# Authorized Field Change

AFC 08901

**Subject:** Hydraulic Full Power Brake System Power Supply

Model: 3200, 4200, 4300, 4400, and HC Bus

**Figure 2** Arrows are pointing to the new harness as it lays over the engine

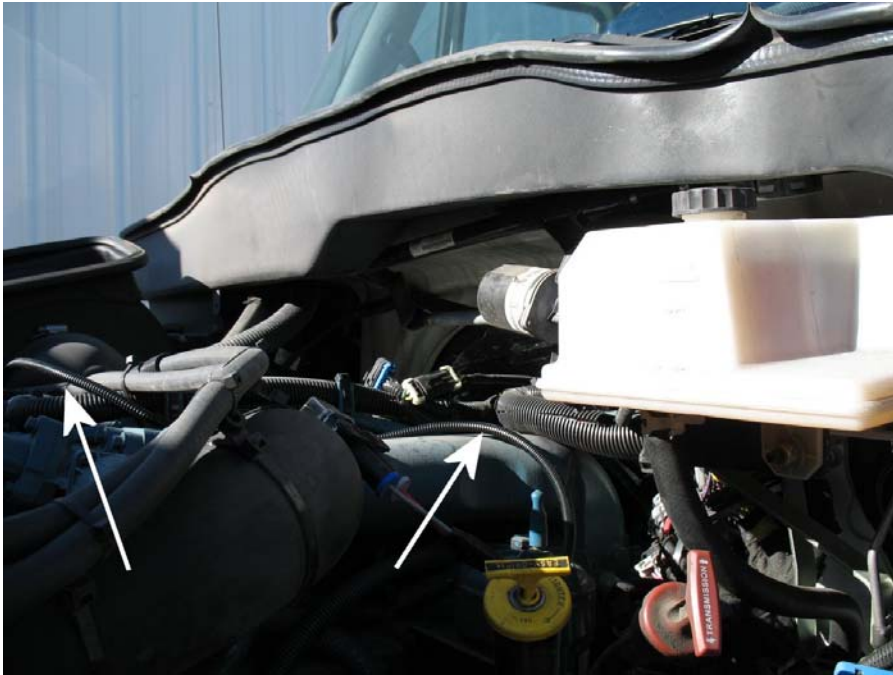
Route (do not secure) the new wiring harness across the top of the engine, following the existing engine harness. Position harness so that the ring terminal end of the harness follows the engine harness down by the alternator positive stud, while the connector end of the harness follows the engine harness back toward the drivers side rear of the engine in the area of the PDC (Power Distribution Center).

**Figure 3**

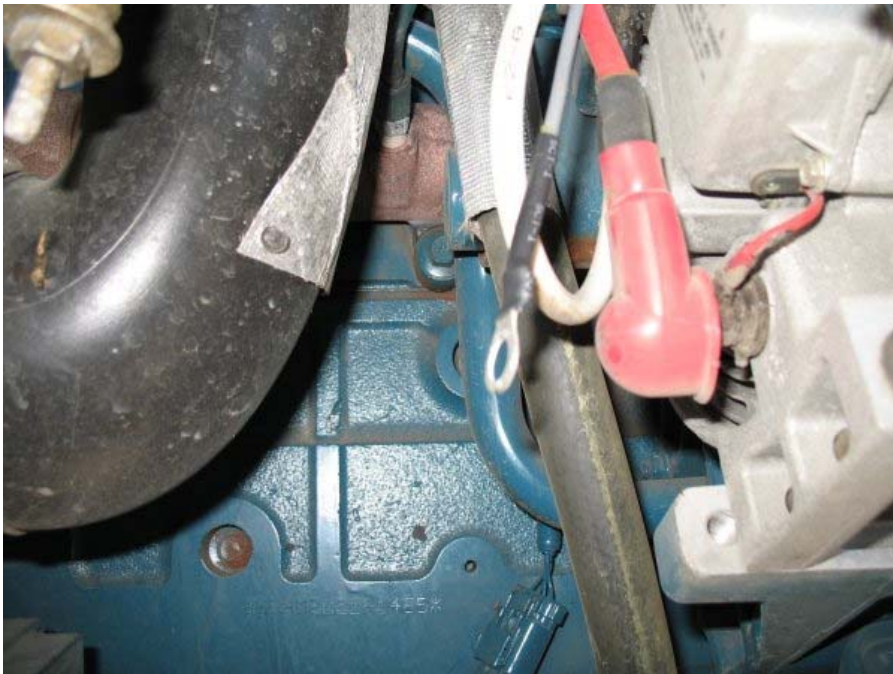
3. Remove nut from positive post on alternator and install end of wiring harness to the positive post and install and tighten nut back on positive post.

**Figure 6**

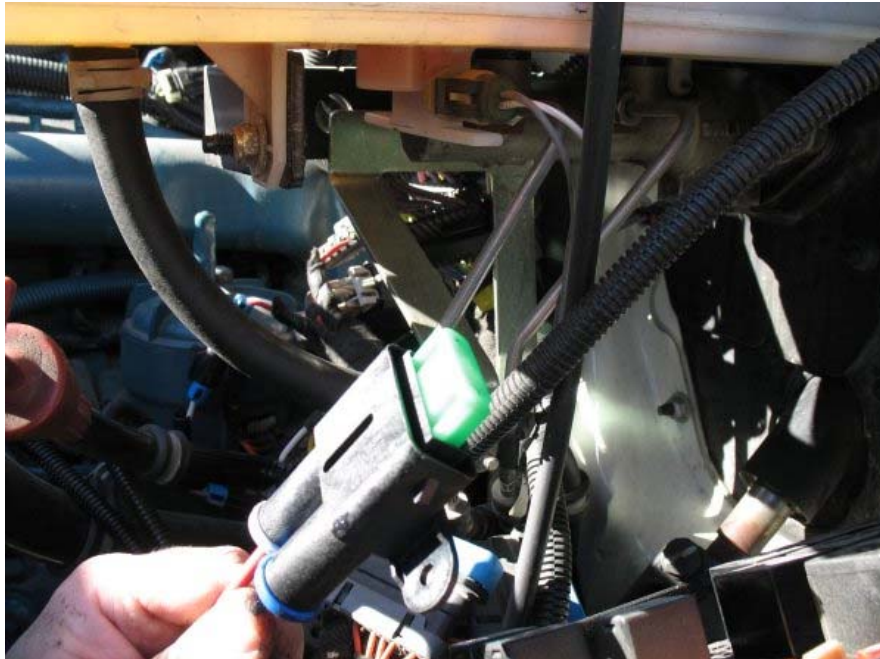
1. Tighten nut to ensure that the bus bar stud and ring terminal are making good contact
2. Remove 30 amp fuse for hydraulic ABS PMP1 PWR.
